# VIRM: IN-SERVICE CERTIFICATION AMENDMENT (WOF AND COF)

April 2021 amendment

MARCH 2021

## LIST OF CHANGES

**Figure 8-1-7. Sample LVVTA electronic data plate**

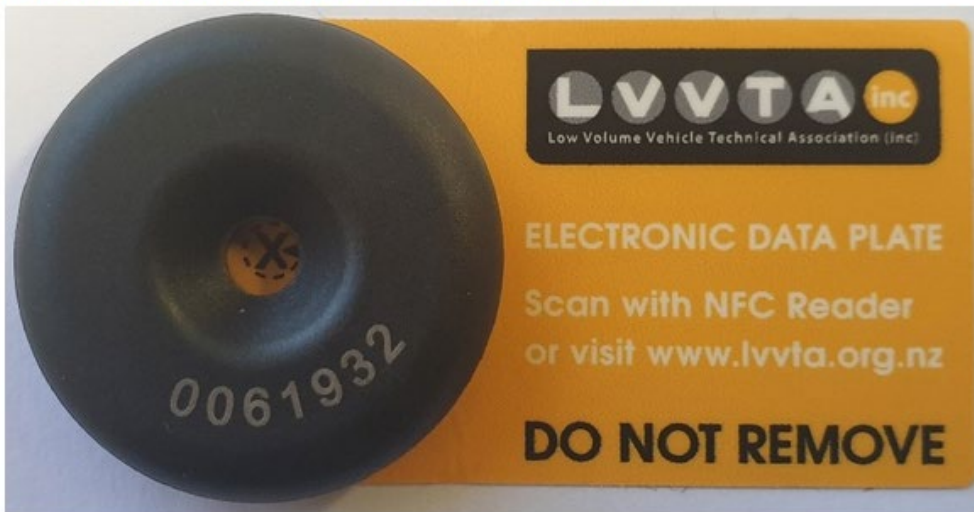
Section	Change description
<b>Introduction</b>	
7 Definitions and abbreviations	LVV plate definition updated to include electronic data plates.
8 Sample certification documents	Sample image of the new electronic LVV plate
<b>General vehicles</b>	
3-1 Structure	Detail added about when a vehicle with an added snorkel should be LVV certified or not.
4-1 Headlamps	Rfr 13e and Note 8 updated. Vehicles should be failed if they have a headlamp HID or LED conversion kit. – They bring the headlamp out of standards compliance by producing poor beam patterns and light that is far too bright to be safe.
4-2 Front and rear fog lamps	Figure 4-2-1 updated to more clearly show the beam pattern and dip.
7-1 Seats and seat anchorages	Content added to note 6 about LVV plate info not matching when seats are removed.
10-1 Tyres and wheels	Note 6 updated to explain that the vehicle inspector should check with the tyre manufacturer for intended use if they are unsure whether a tyre is a winter tyre or not.

<b>Low volume vehicle plate, label or authority card</b>	means a plate, <b>electronic data plate or disc</b> , label, or authority card issued in accordance with the Low Volume Vehicle Code.  For more information see <a href="https://lookup.lvvtta.org.nz">https://lookup.lvvtta.org.nz</a> and <b>Inspection news issue 5</b>
--	--

Figure 4-2-1. Front fog lamp characteristics

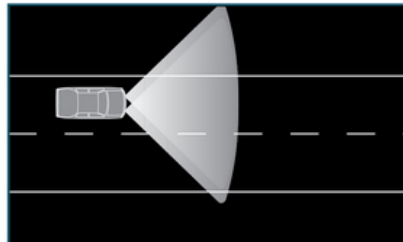
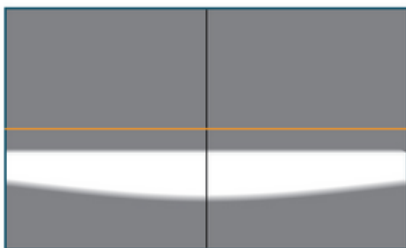
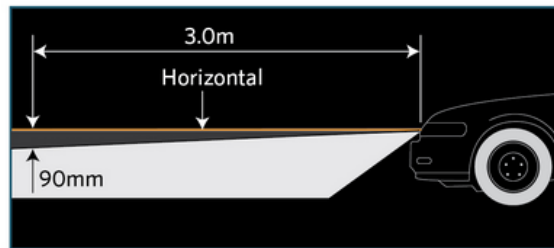
<b>Forklifts</b>	
4-1 Headlamps	See motorcycles
4-2 Front and rear fog lamps	Figure 4-2-1 updated to more clearly show the beam pattern and dip.
<b>Tractors</b>	
4-1 Headlamps	See motorcycles
<b>Unclassified vehicles</b>	
4-1 Headlamps	See motorcycles
4-2 Front and rear fog lamps	Figure 4-2-1 updated to more clearly show the beam pattern and dip.
<b>Technical bulletins (general)</b>	
13 Acceptable overseas proof of modification	2018/858 is an acceptable code that has been introduced in Europe. It is used in the same way as the 2007/46 code.
<b>Technical bulletins (CoF)</b>	
1 Expiry dates recorded on ID label/plate and HVS certificate (LT400)	<ul style="list-style-type: none"> <li>1a updated to 'towing connections' to provide consistency across the VIRM</li> <li>1b regarding Towbar rated over 200kg deleted as no longer relevant (recertification should have occurred).</li> </ul>
2 OEM wheel RIM options	Email address added to request Waka Kotahi to add new content to, or update, the page.

**Figure 3-1-3. Rust heave limits**

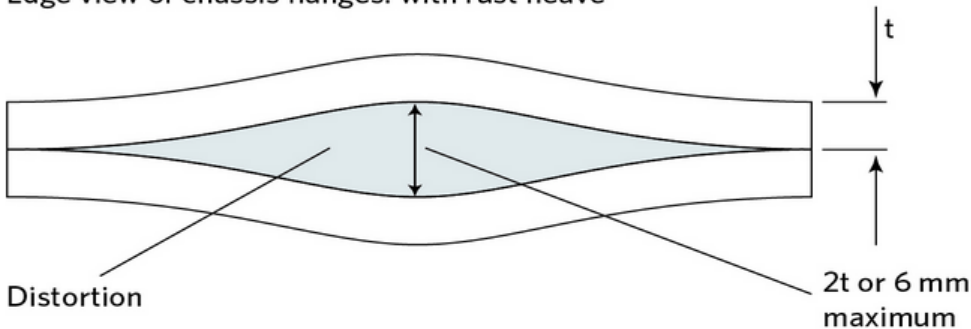
<b>Heavy vehicles</b>	
4-1 Headlamps	See general vehicles.
4-2 Front and rear fog lamps	See general vehicles.
8-1 Service brake, parking brake and heavy vehicle emergency brake	<ul style="list-style-type: none"> <li>Wheelbase modifications completed prior to 1/04/2021 that do not have HVEK certification for a wheelbase change may be passed for CoF but must have HVEK certification completed before the next CoF. Notes must be recorded showing the completion of this inspection and actions needed to be taken before next CoF.</li> <li>Any vehicles presented for inspection 1 year after 01/04/2022 will not pass for CoF without the correct certification.</li> <li>All vehicles presented for first time entry compliance must meet the requirements for HVEK certification immediately.</li> </ul>
10-3 Mudguards	<ul style="list-style-type: none"> <li>Two new reasons for rejection introduced with regard to mudguards on logging trucks to align with the Land Transport Rule: Vehicle Equipment 2004.</li> <li>New image added to assist vehicle inspectors with mudguard requirements</li> </ul>

Apply similar criteria (twice material thickness or 6 mm maximum) for corrosion in other parts of structural members

**Note:** where the flanges are of different thickness,  $t$  shall be taken as the minimum of these.

Rust heave beyond the limits described above is acceptable only if an HVS certifier with the HVEC category has confirmed in writing that at the time of inspection the identified chassis rust heave on the vehicle remains within safe tolerance of the vehicle's state of manufacture. Confirmation from the HVS certifier should be kept with the checksheet. The identity of the HVS certifier must be recorded in the Landata GNOTE page. This assessment is only valid for that specific CoF inspection.
